## Central Valley Regional Water Quality Control Board

### **REVIEW OF PHASE 1 WORK PLAN FOR SUBSURFACE INVESTIGATIONS, VALLEY WATER MANAGEMENT COMPANY, FEE 34 FACILITY AND RACE TRACK HILL AREA, EDISON, KERN COUNTY**

SUBJECT: **REVIEW OF PHASE 1 WORK PLAN FOR SUBSURFACE INVESTIGATIONS;  
VALLEY WATER MANAGEMENT COMPANY, FEE 34 FACILITY AND RACE TRACK  
HILL AREA, EDISON, KERN COUNTY**

FIGURE 1

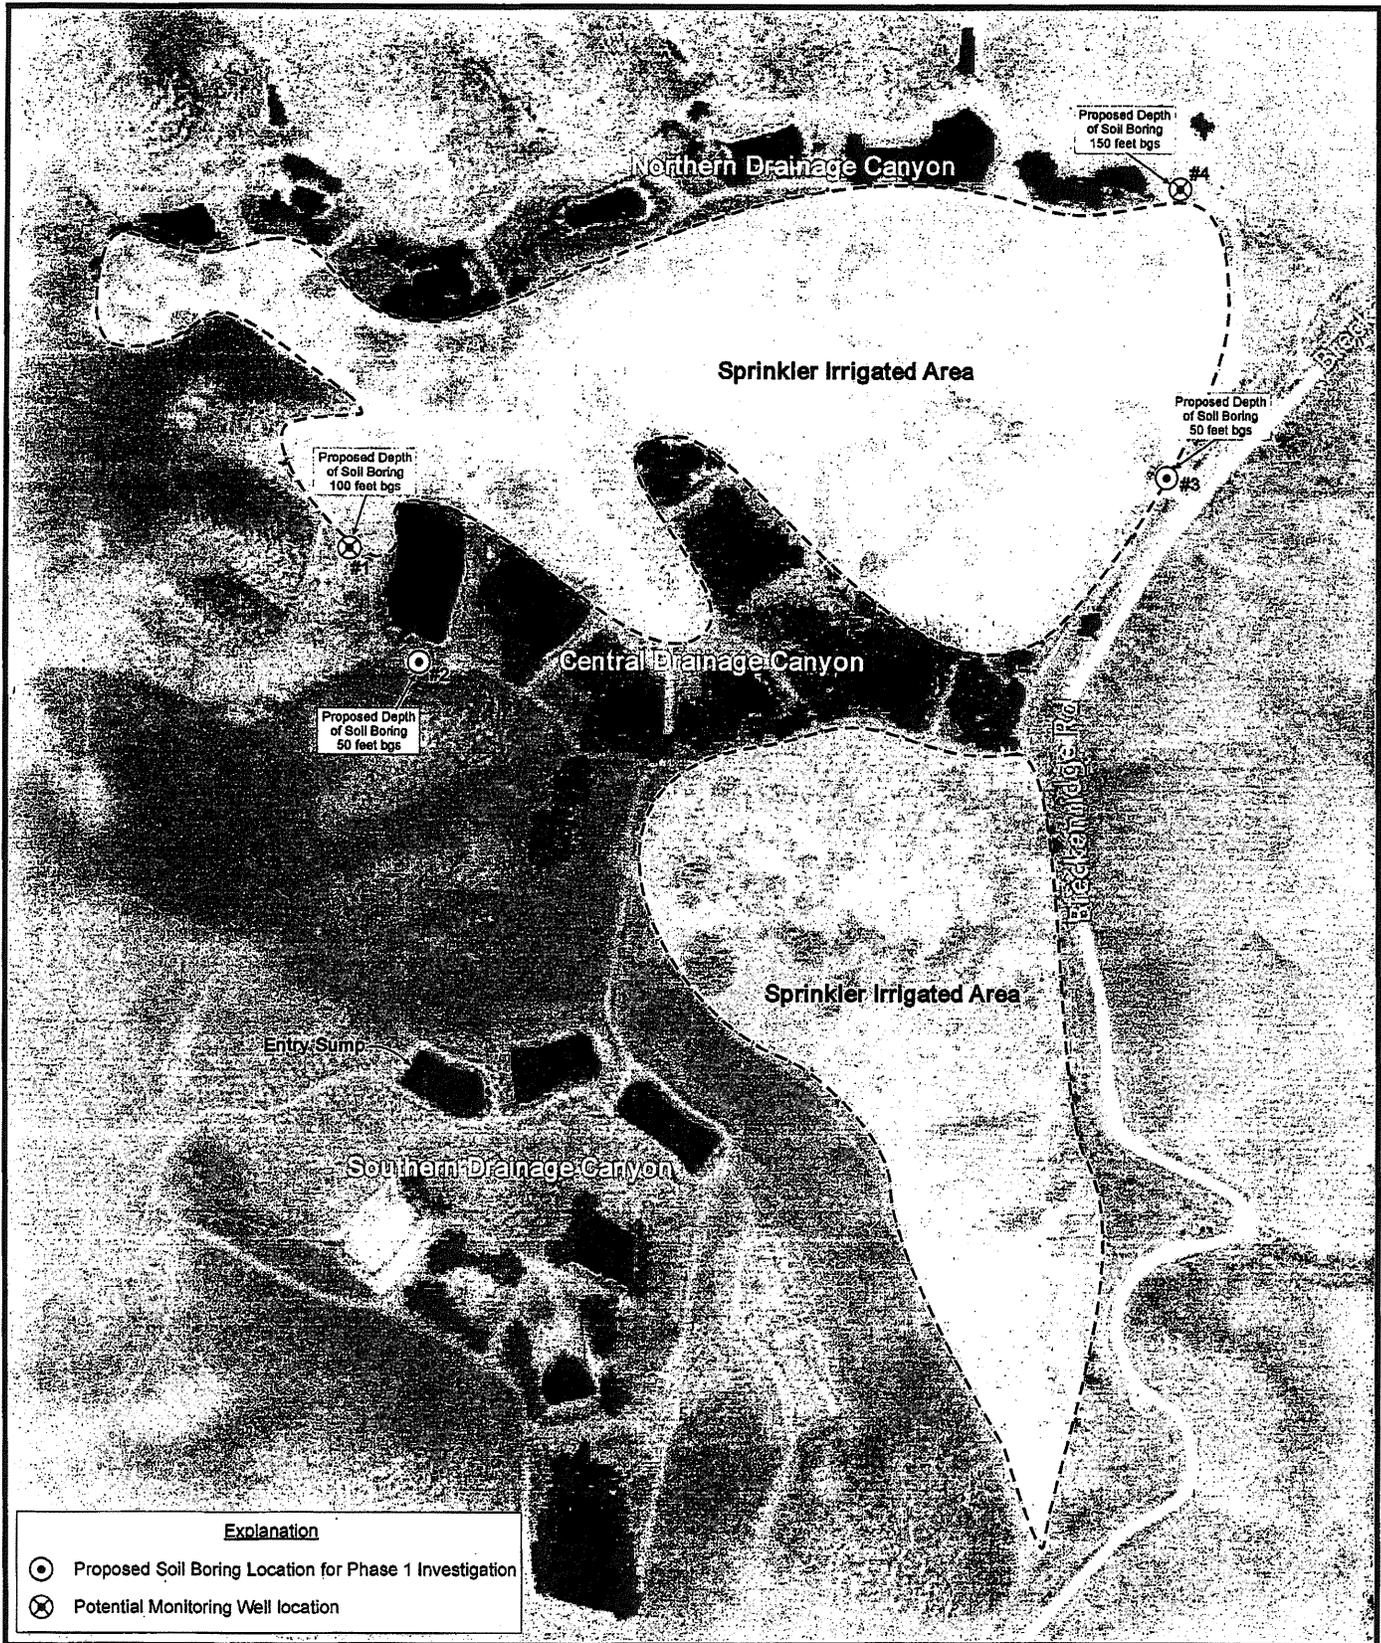
2. One soil boring would be advanced to assess potential impacts below the two unlined sumps (see Figure 1 for proposed boring location). The boring would be advanced to a maximum depth of 200 feet bgs. If groundwater is encountered at a lesser depth (<200 feet), the soil boring would be terminated at a depth of five feet below the top of groundwater. Soil samples would be collected at five-foot intervals to a depth of 50 feet and at ten-foot intervals for the remainder of the boring. A maximum of 25 samples would be submitted to a California ELAP-certified laboratory for analysis of EC, chloride, boron, pH, Total Petroleum Hydrocarbons as crude oil (TPHc), and moisture content.
